To: ICC-ES Evaluation Committee
From: Mahmut Ekenel and Russ Krivchuk, ICC-ES Staff
Date: January 28, 2010
Subject: Proposed Acceptance Criteria for Continuous and Semicontinuous
Fiber-reinforced Grid Connectors Anchored in Concrete, Subject
AC422-0210-R1 (ME/RK)

**PROPOSED ACCEPTANCE CRITERIA FOR CONTINUOUS OR
SEMICONTINUOUS FIBER-REINFORCED GRID
CONNECTORS ~~ANCHORED IN CONCRETE~~ USED IN
COMBINATION WITH RIGID INSULATION IN CONCRETE
SANDWICH PANEL CONSTRUCTION**

AC422

Proposed January 2010

FIGURE 2 — TYPICAL ~~DOBLE~~ DOUBLE-SHEAR SPECIMEN

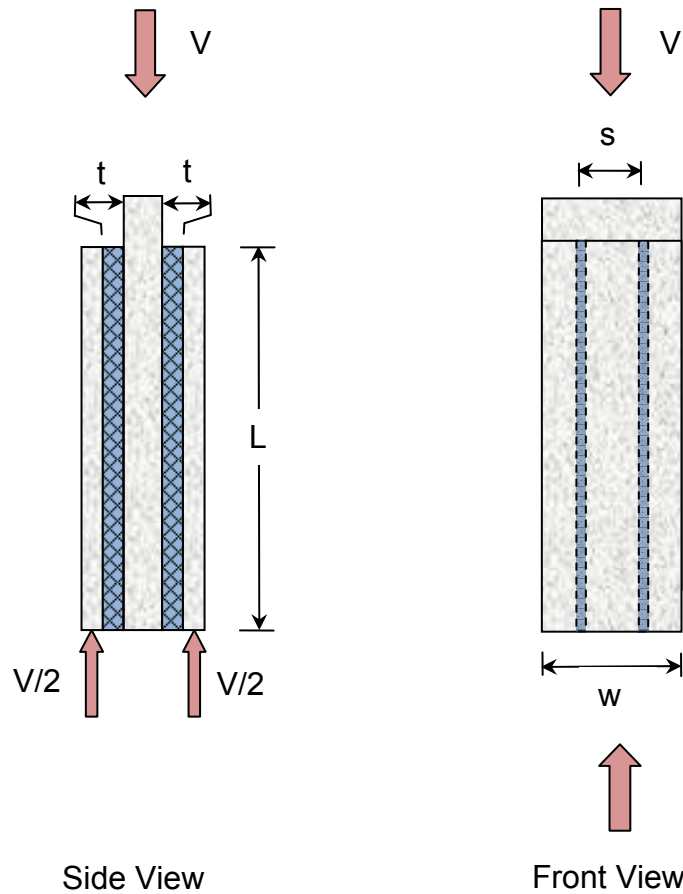
6. Revise the title of Figure 2 to “TYPICAL DOUBLE-SHEAR SPECIMEN.”
7. Revise the title of Figure 3 to “TYPICAL DOUBLE-SHEAR SPECIMEN UNDER LOAD.”
